NORTH ANNA EARLY SITE PERMIT APPLICATION

North Anna Early Site Permit Application Description of Changes in Revision 2	
Affected Section, Table, or Figure	Reason for Change
Acronyms/Abbreviations/Initialisms

DOMINION NUCLEAR NORTH ANNA, LLC
NORTH ANNA EARLY SITE PERMIT APPLICATION
RESPONSE TO NRC QUESTIONS AND REVISION 6 TO THE NORTH ANNA ESP APPLICATION

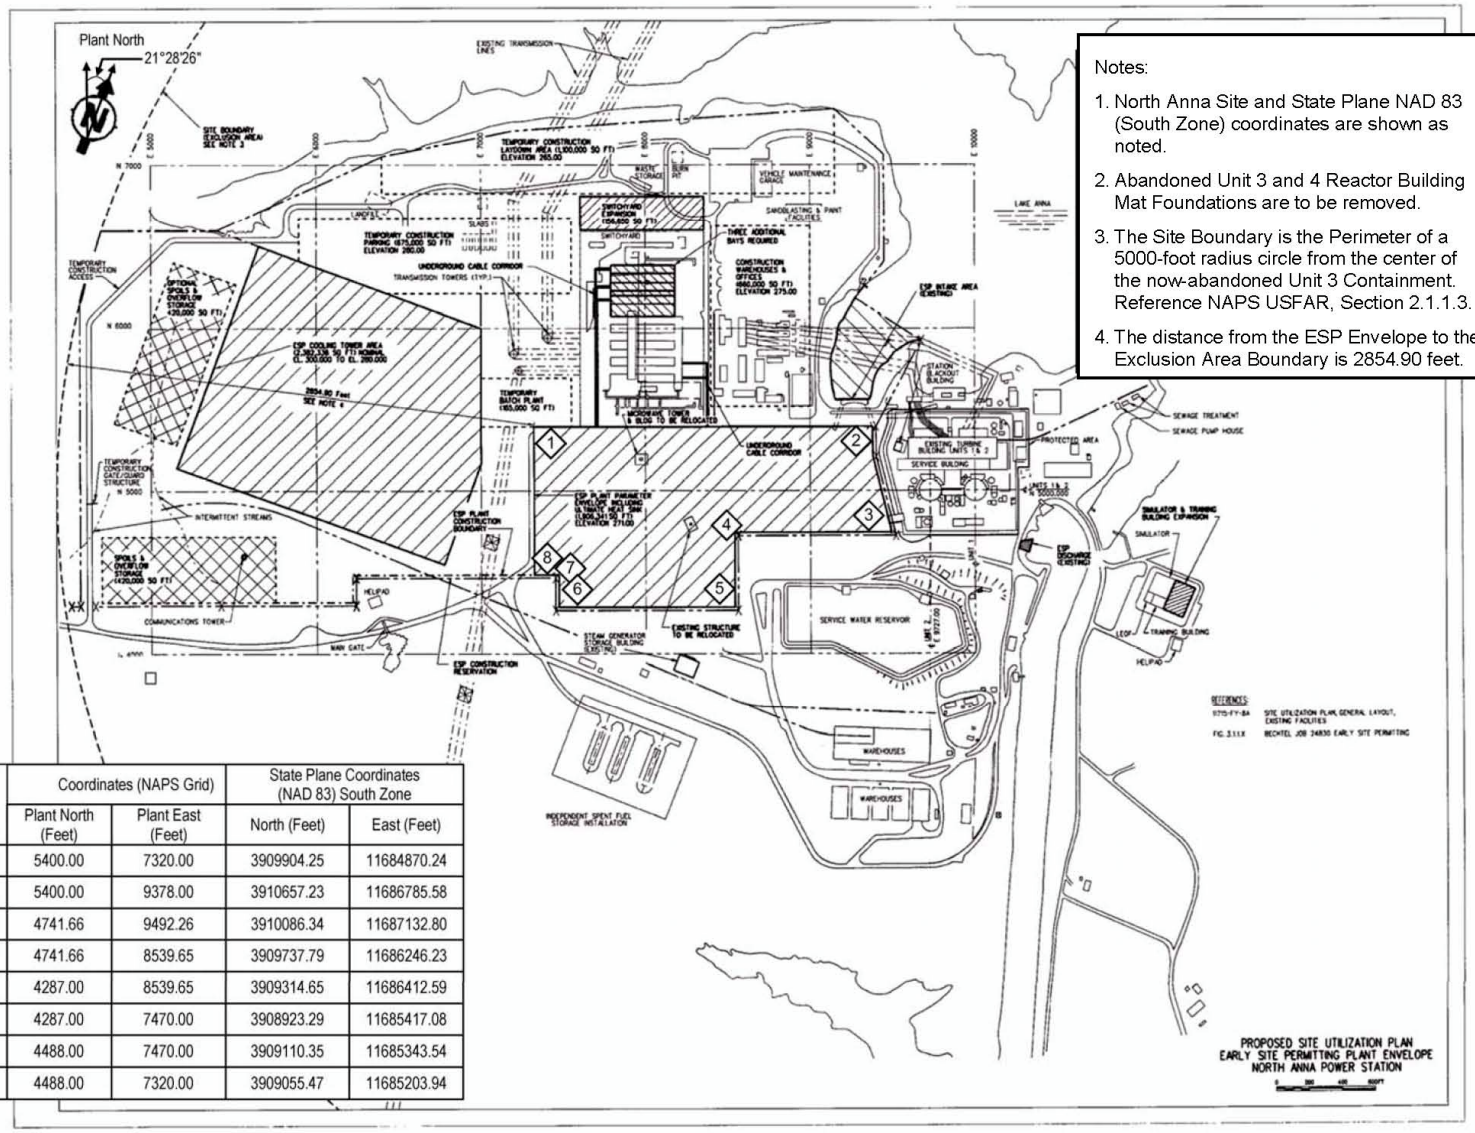
Coordinates for the ESP site footprint were submitted to the NRC in response to Draft Safety Evaluation Report (DSER) Open Item 2.4-1 (Dominion Letter 05-785B dated March 3, 2005).

As discussed in a July 5, 2005 conference call with NRC Staff, upon further review, it has been determined that the coordinates identified in Figure 1 of the DSER Open Item 2.4-1 response contained errors.

A corrected version of Figure 1 is provided on the next page.

None. Figure 1 on the next page is not included in the North Anna ESP Application.

Figure 2.5-55A **Selected Horizontal and Vertical OBE and SSE Spectra for the Hypothetical Rock Outcrop Control Point at the Top of Zone III-IV Material (Representative Elevation 250 ft, 3300 ft/sec Shear Wave Velocity)**

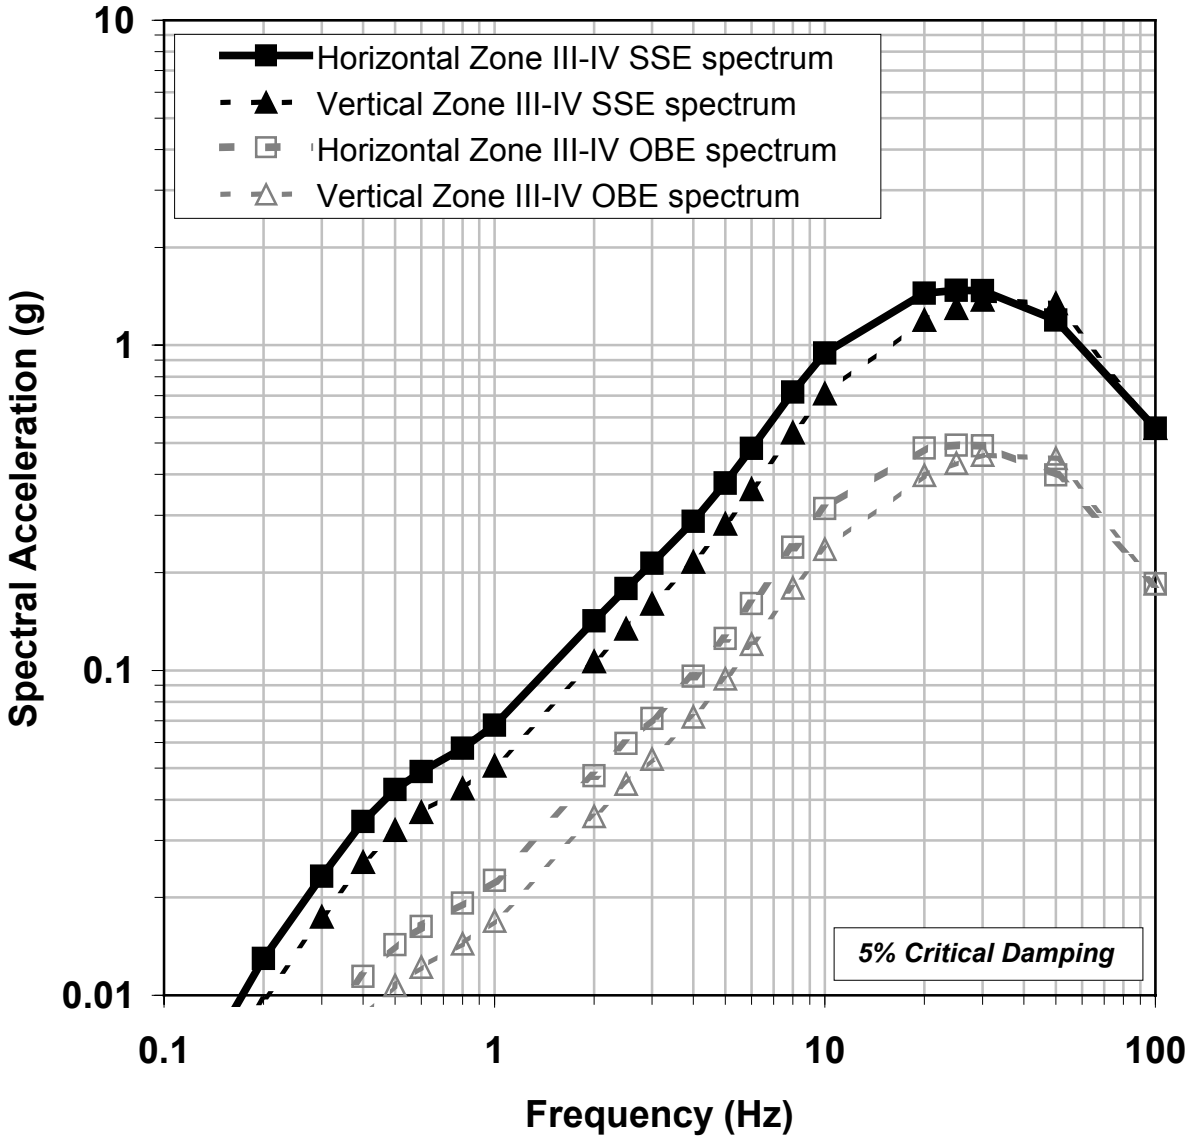
In Dominion's response to DSER Open Item 2.5-2 (Dominion Letter 05-194 dated March 30, 2005), a new SSAR figure, Figure 2.5-55A, was included titled:

Revision 4 of the North Anna ESP Application included an incorrect version of SSAR Figure 2.5-55A. (A duplicate copy of SSAR Figure 2.5-55 was inadvertently included as SSAR Figure 2.5-55A.)

The correct version of SSAR Figure 2.5-55A has been incorporated in Revision 5 of the ESP Application.

In Revision 5 of the ESP Application, SSAR Figure 2.5-55A has been replaced with the correct version shown on the next page.

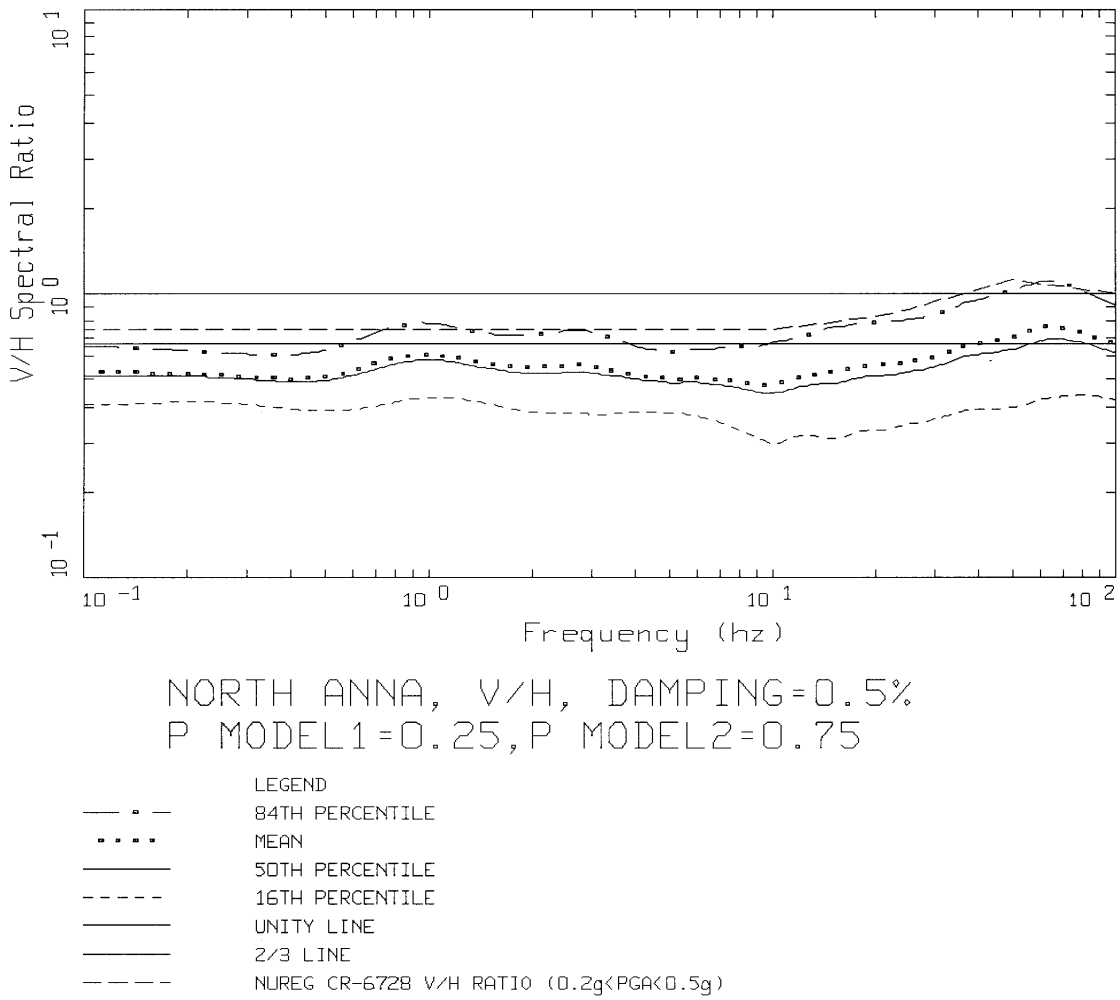
The statistical results of the V/H spectral ratios for the 0.5% damping level are shown in Figure 2. For comparison purposes, the V/H ratio for the 0.2g<PGA<0.5g bin from NUREG/CR-6728, which was used in SSAR Table 2.5-27A, is shown in Figure 2.

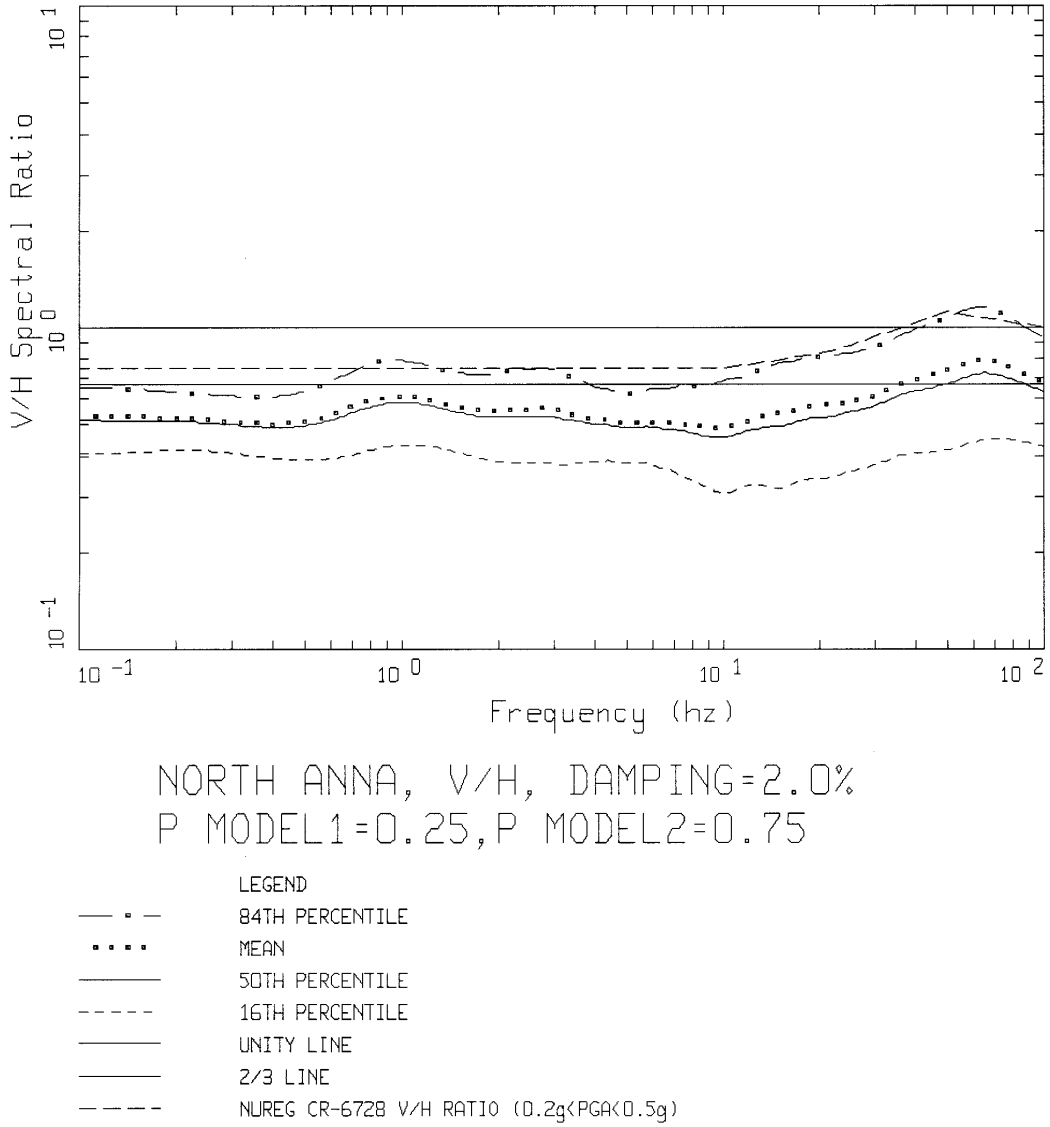
The 16th, 50th, and 84th percentiles and mean V/H ratios are shown in Figure 4 for the 2.0% damping case and listed in Table 2. For comparison, the V/H ratios from NUREG/CR-6728 for the 0.2g<PGA<0.5g case, which was used for SSAR Table 2.5-27A, are also shown in Figure 4 and listed in Table 2. On average, the mean V/H ratios from the site-specific analysis are approximately 30% lower (ranging from 18-35% lower) over the complete frequency range of 100 Hz to 0.1 Hz than the V/H ratios used in SSAR Table 2.5-27A. At the 84th percentile, the site-specific V/H ratio values are on average 8% lower (ranging from 19% lower to 5% higher) over the entire frequency range than the SSAR Table 2.5-27A V/H ratio values.

The site-specific analysis included the deaggregation information from the high frequency (i.e., 5-10 Hz) controlling earthquake only. If a more detailed analysis were performed, the deaggregation events from the low-frequency (i.e., 1-2.5 Hz) deaggregation would be included. In addition, the 5-10 Hz deaggregation events for distances greater than 75 km were included in the 75 km case. These factors would lead to a more conservative V/H ratio (shown in Figure 4) for the lower frequency range than for the higher frequency range.

NORTH ANNA UNIT 3 CLOSED CYCLE CIRCULATING WATER SYSTEM DIAGRAM

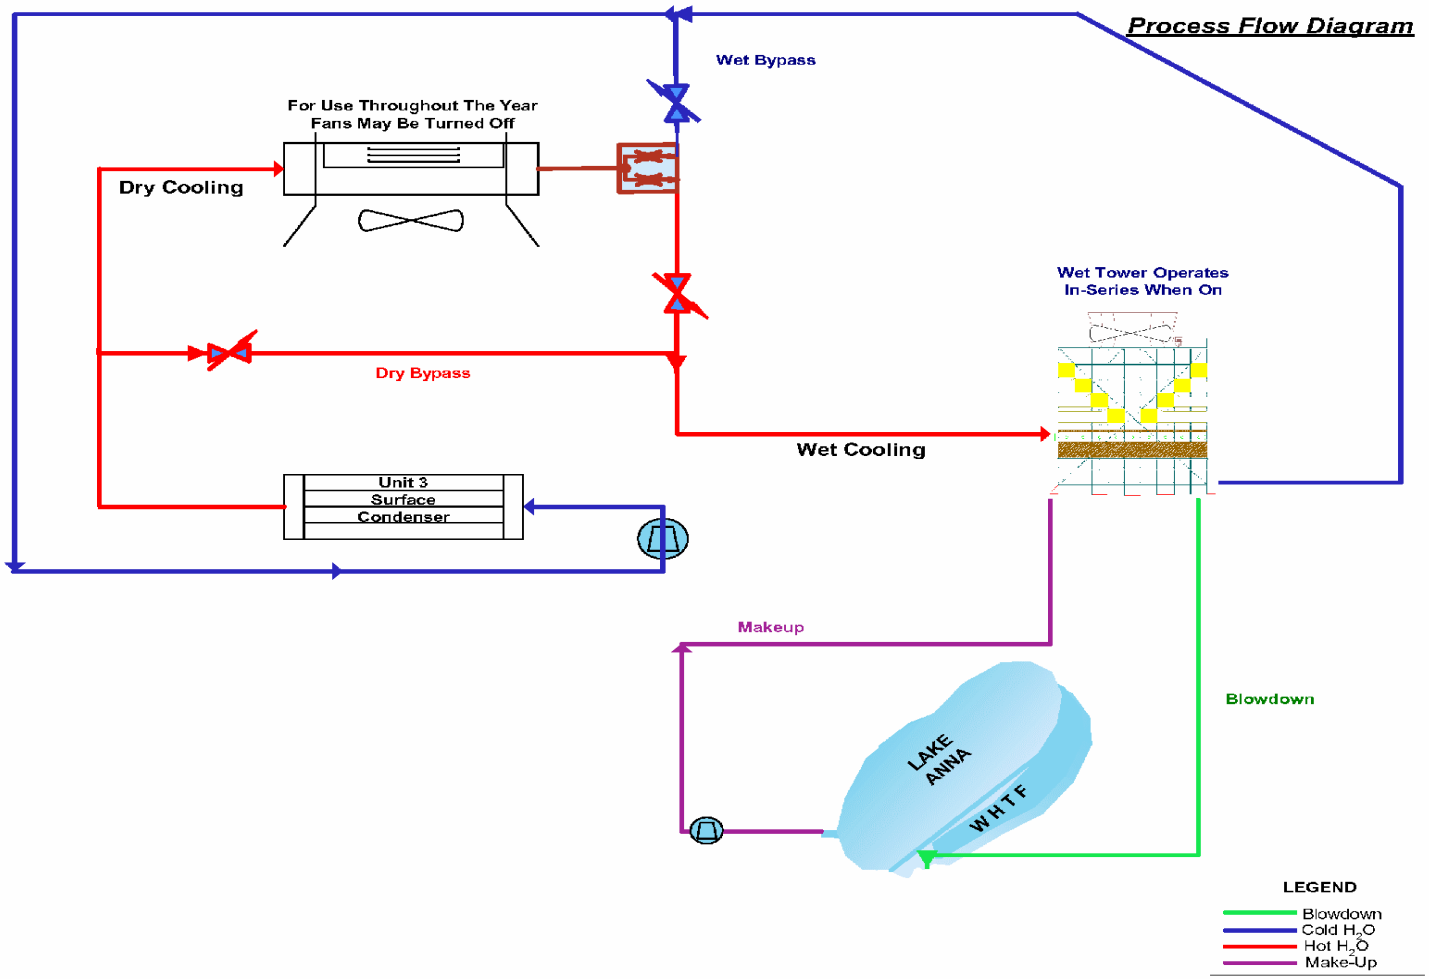
For ER Section 3.4.1.1, the discussion has been revised to include the description that the make-up water is required in order to compensate for water lost from the closed-cycle cooling system due to evaporation, blowdown, and drift. In the energy conservation (EC) mode[1], these losses would be no greater than 1.67 E4 gpm for evaporation, 5.57 E3 gpm for blowdown, and 8 gpm for drift. In the maximum water conservation (MWC)

ER Section 3.4.1.1 is revised to include the diagram of the cooling system shown in the attached Figure and to describe examples of the water saving features that could be used in the wet towers. The figure in the ER Section also includes a plant service water system described in the section.

Figure 1: Flow Reduction ($\Delta Q = Q_2 - Q_3$) over Dam (from October 1978 to April 2003)

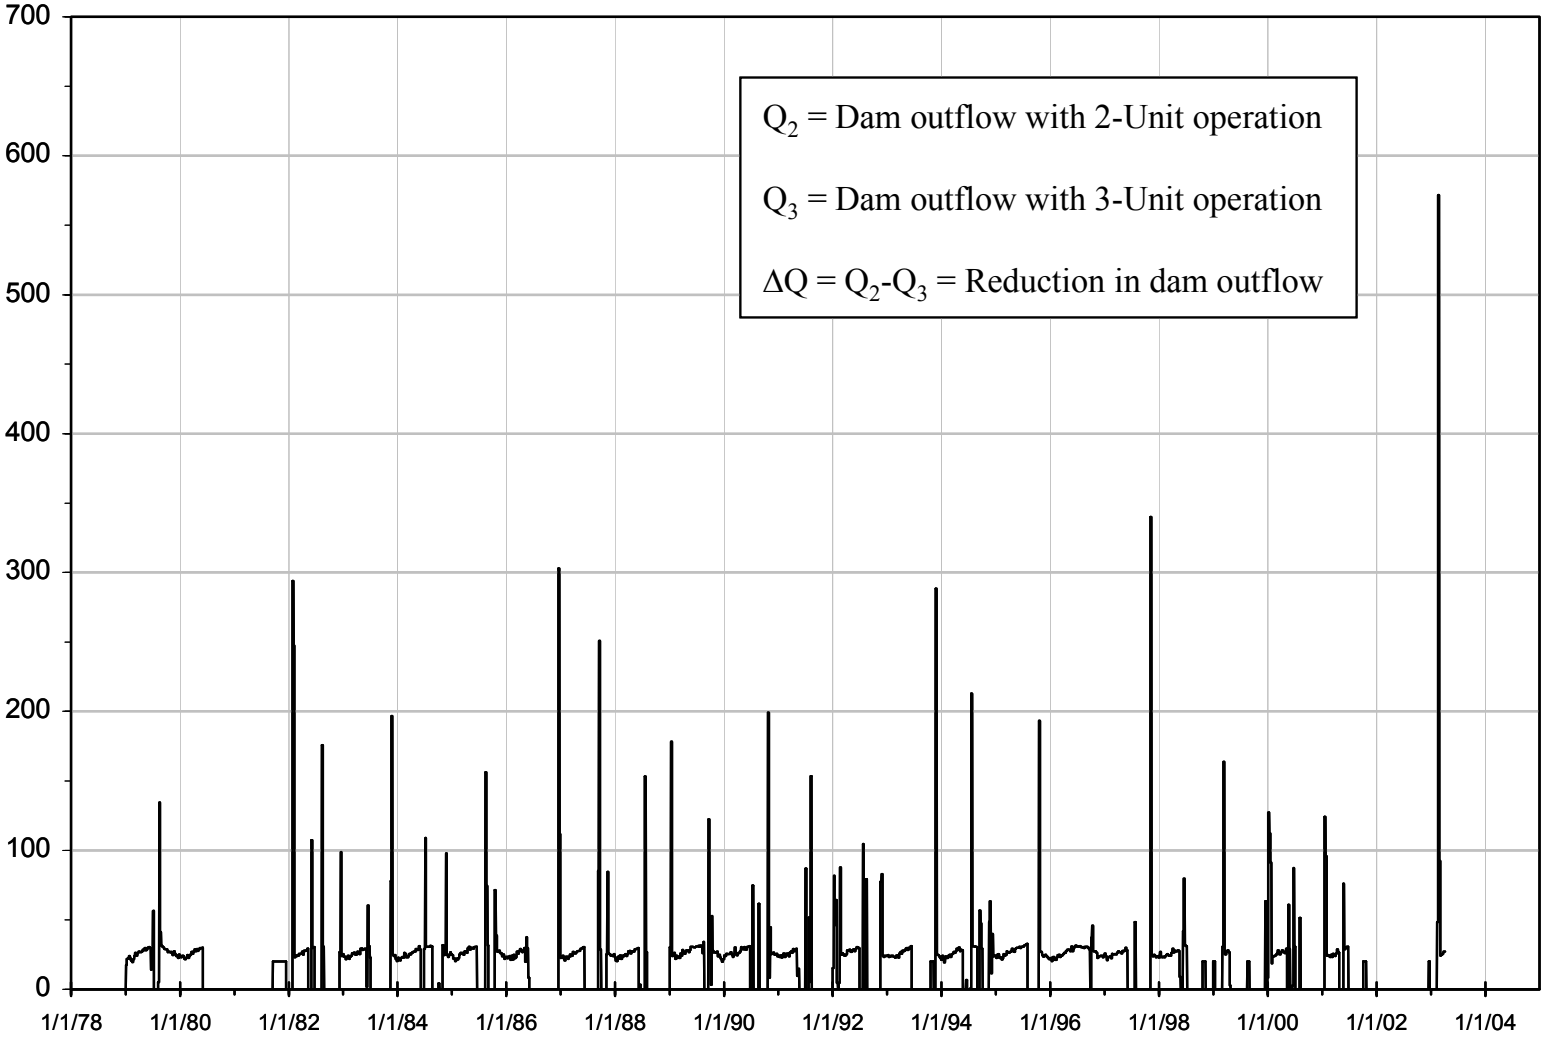
Certain characteristics of the changes in flow at the dam between 2-unit and 3-unit operation are apparent from these calculations as illustrated in Figure 1:

- There are short periods with a difference of 20 cfs, e.g., when 2-unit operation is releasing 40 cfs minimum flow, but 3-unit operation, with a lower lake level, would release 20 cfs, which would have occurred seven times in the 1978-to-2003 period, lasting one week to 3 months;

- There are periods when the 2-unit dam release is much larger (up to 550 cfs, but mostly 100 to 350 cfs) than the 3-unit release, due to the fact that runoff after a dry period fills the reservoir level to elevation 250 ft more rapidly for the 2-unit case and nearly all the river inflow is passed over the dam for a short period before the reservoir would have filled under the 3-unit scenario. Flow differences above 100 cfs would have occurred approximately 25 times in the 1978-to-2003 period, with each episode lasting a few days to two weeks.
